STAFF REPORT

Agenda Item D1: Major Land Development Master Plan application of GX3 LLC, 250 David Court, Calverton, NY 11933 for a proposed warehouse and distribution facility totaling 200,000 square feet

Riverhead Building Supply Traffic Report Peer Review

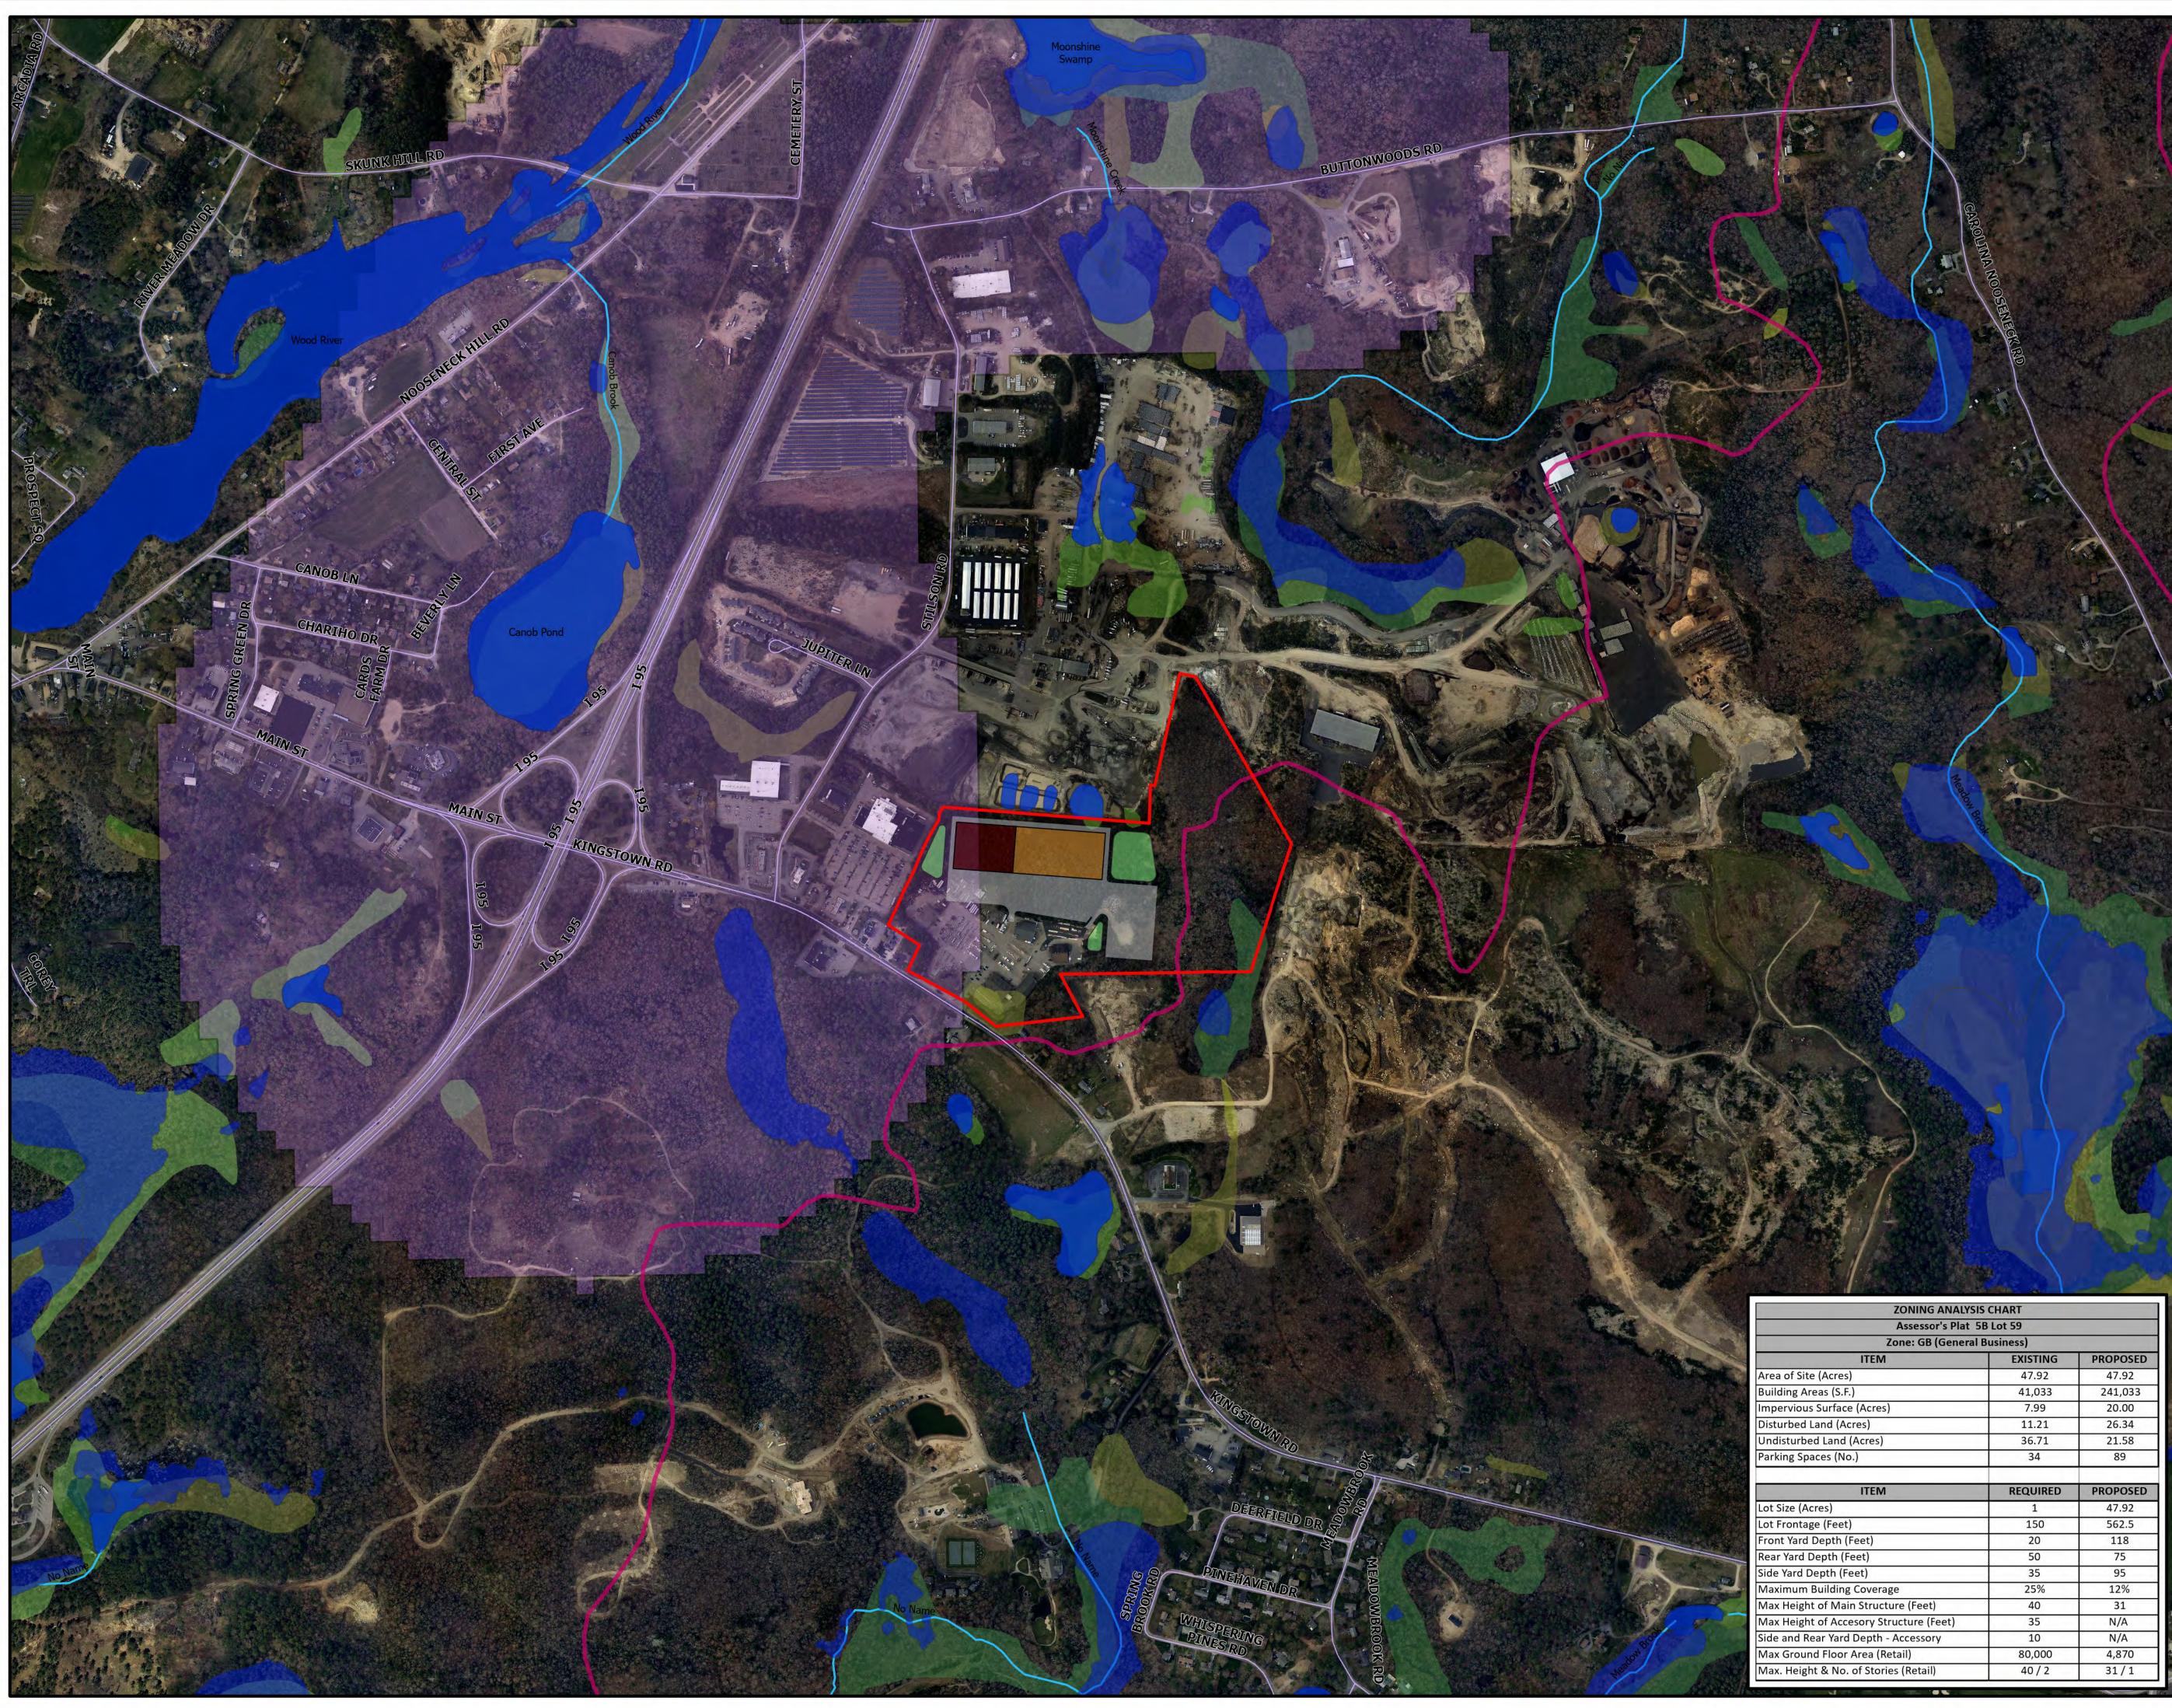
The TIA summarized the existing and proposed conditions of 38 Kingstown Road. The number of parking spaces and loading docks in the write-up is not consistent with the Development Overlay Plan (Site Plan), dated April 6, 2023, however, the Application for the Master Plan is consistent with of the site plan indicating 34 existing parking spaces and 23 loading docks/bays.

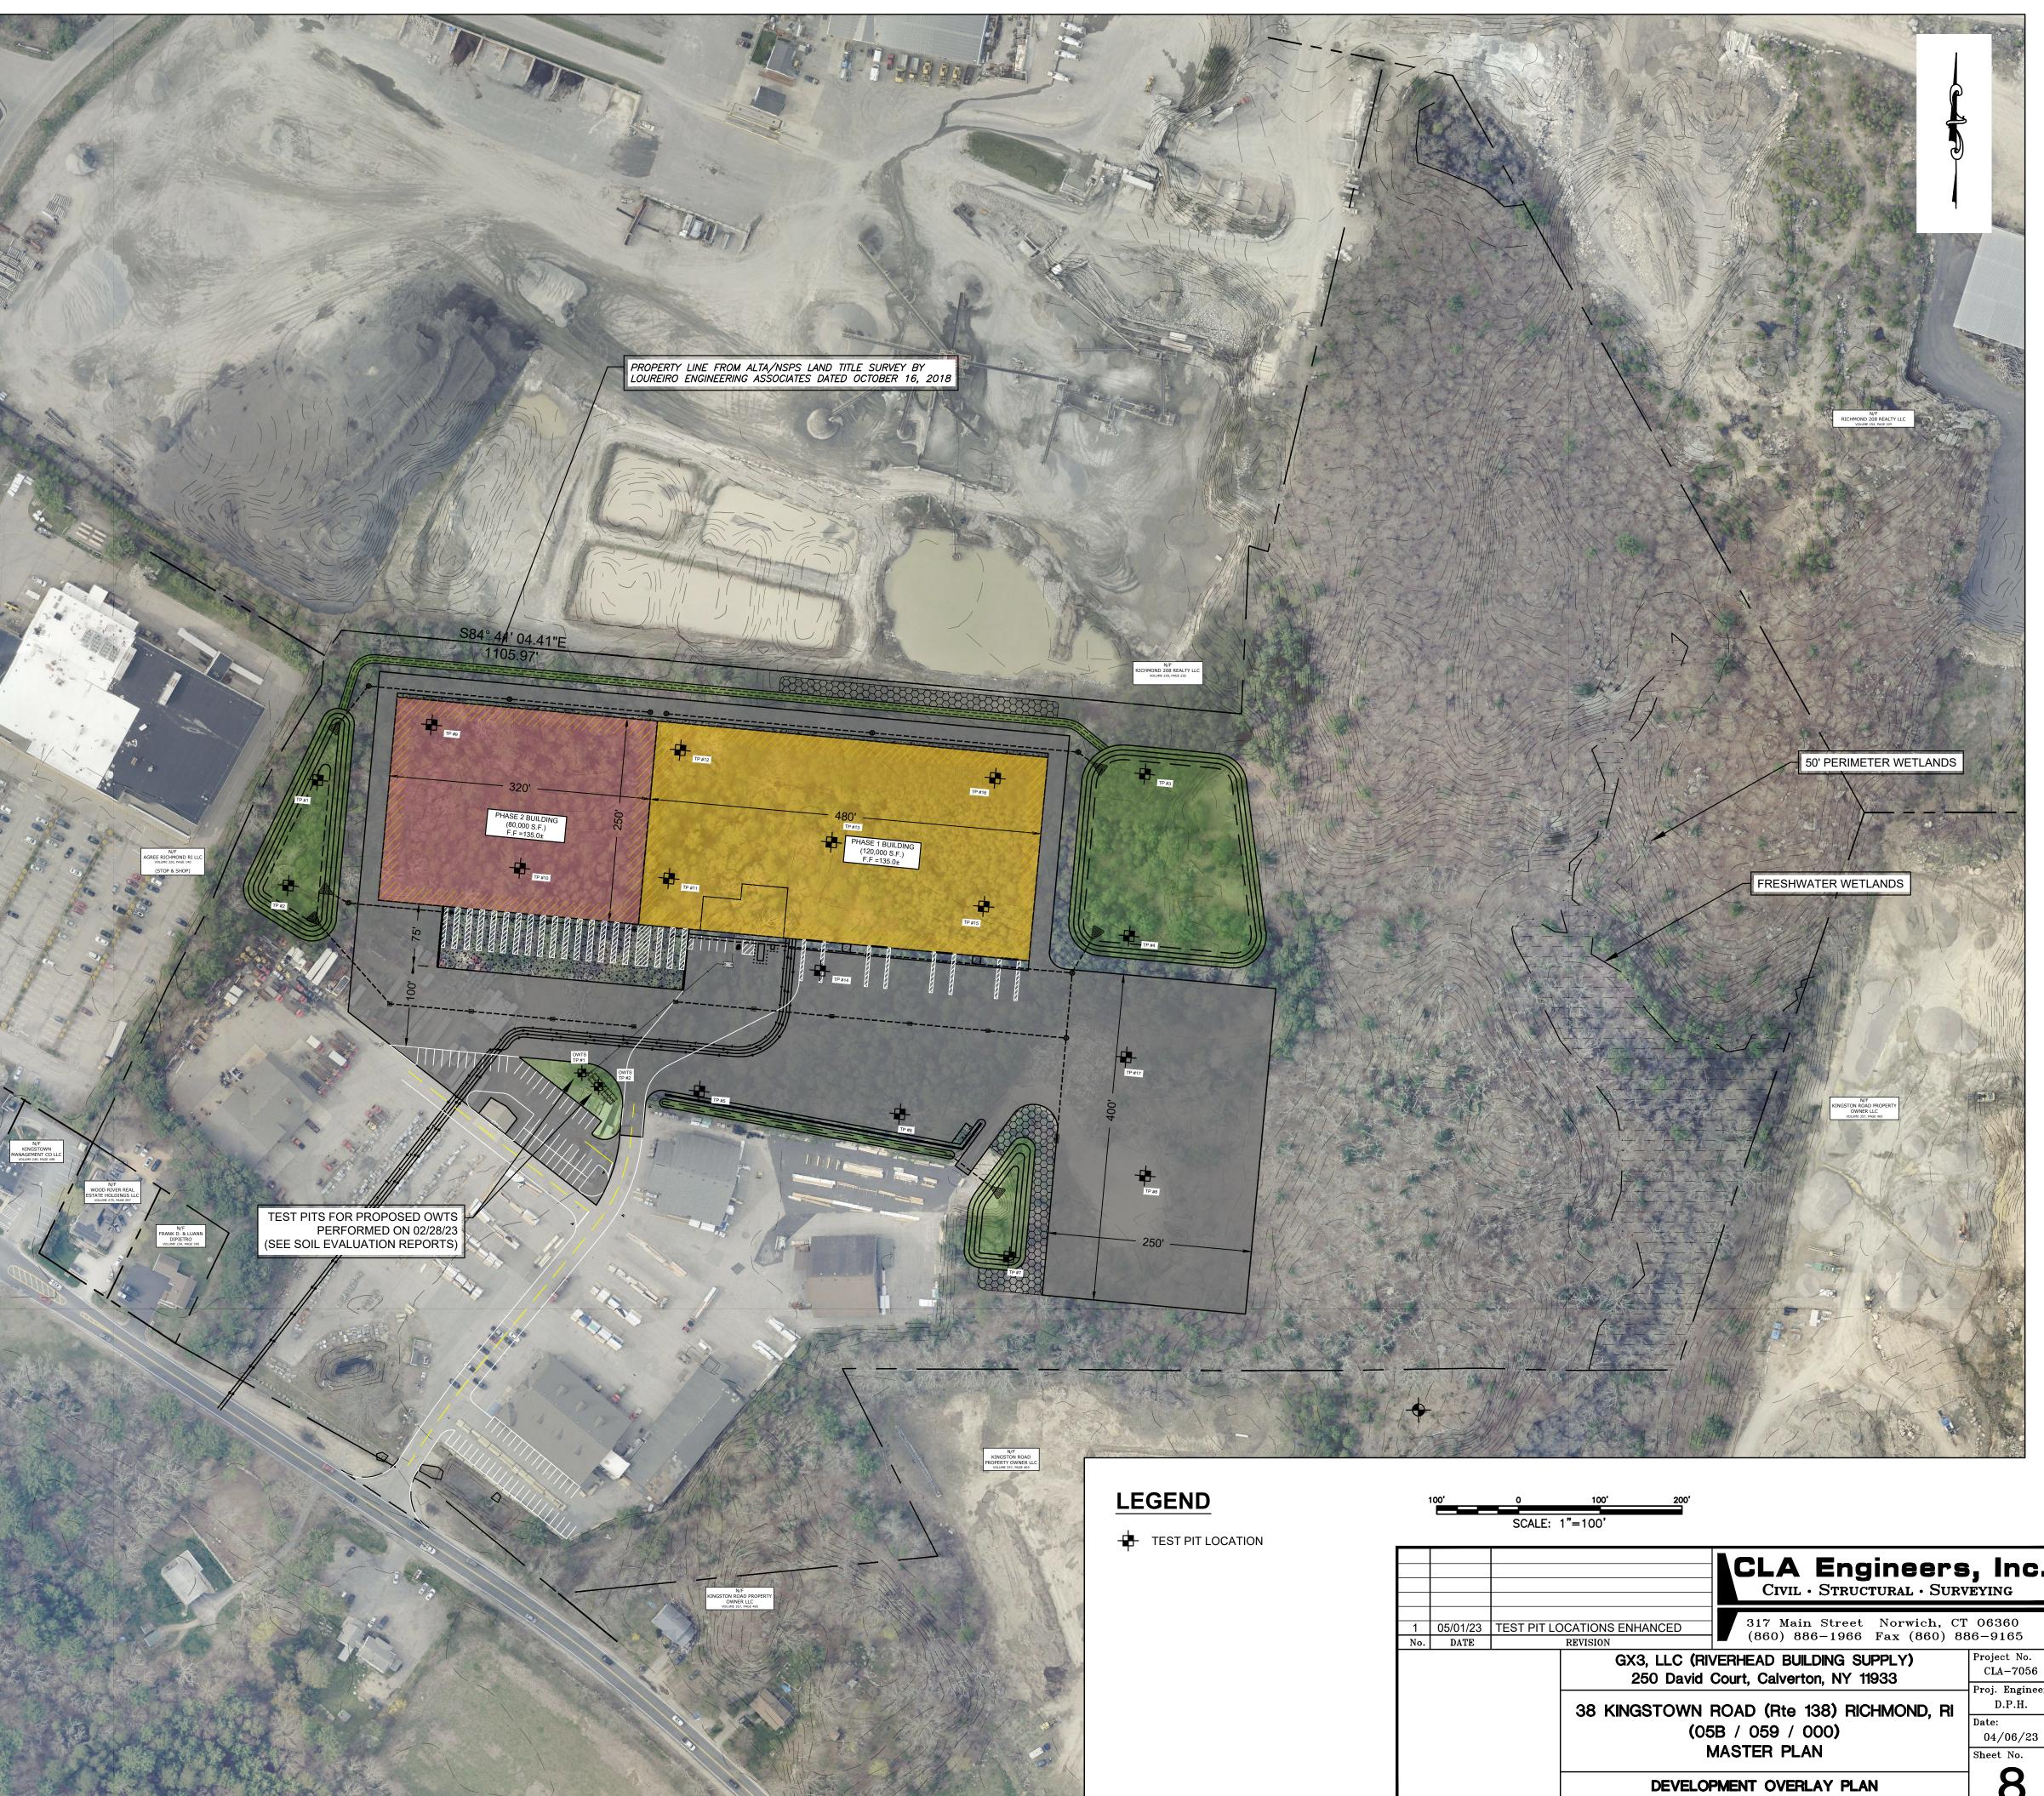
The Development Overlay Plan depicting the soil test pit locations (Sheet 8) has been revised to enhance the visibility of the test pit locations and the appropriate plan copies are enclosed.
